Safety Evaluation Report
Related to the License Renewal of
R.E. Ginna Nuclear Power Plant

Docket No. 50-244

Rochester Gas & Electric Corporation

Manuscript Completed: May 2004

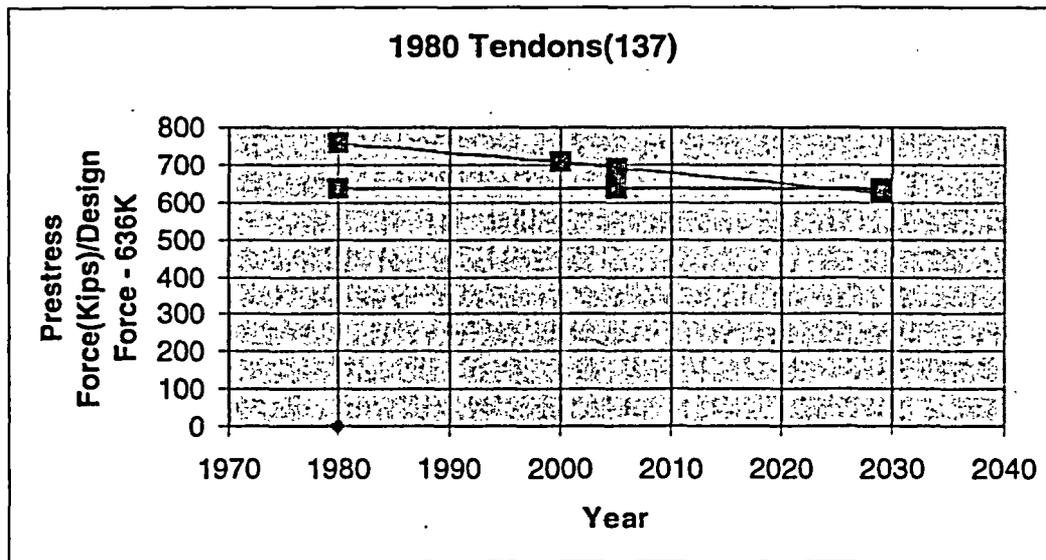
In addition to the review of Section 4.5 of the LRA, the staff reviewed the relevant information in Sections 2.4.1, 3.6, B2.1.3, B3.3, and Section 4.7.4 of the LRA. In the earlier years (1979–1980), the applicant had experienced lower prestressing forces than the minimum required value (MRV) estimated at 40 years. In order to understand the present state of the prestressing forces in the Ginna containment, the staff requested that the applicant provide the following additional information in RAI 4.5-1:

1. For the 137 tendons which were retensioned in 1980, the applicant was requested to provide the predicted lower limit line, MRV expected in 2005 and at 60 years (if not retensioned in 2005), a trend line for this group of tendons, and prestressing force values as points above and below the trend line measured during prior inspections.
2. The applicant was requested to provide the same information for the remaining 23 tendons for the inspections performed after the 1969 retensioning.

- a) Based on the available test information for this set of 137 tendons that were retensioned in 1980, the below graph shows the trend line from 1980 projected through 2005, and out to 2029. The graph also includes a constant line at 636 kips, which is the minimum design prestress force.
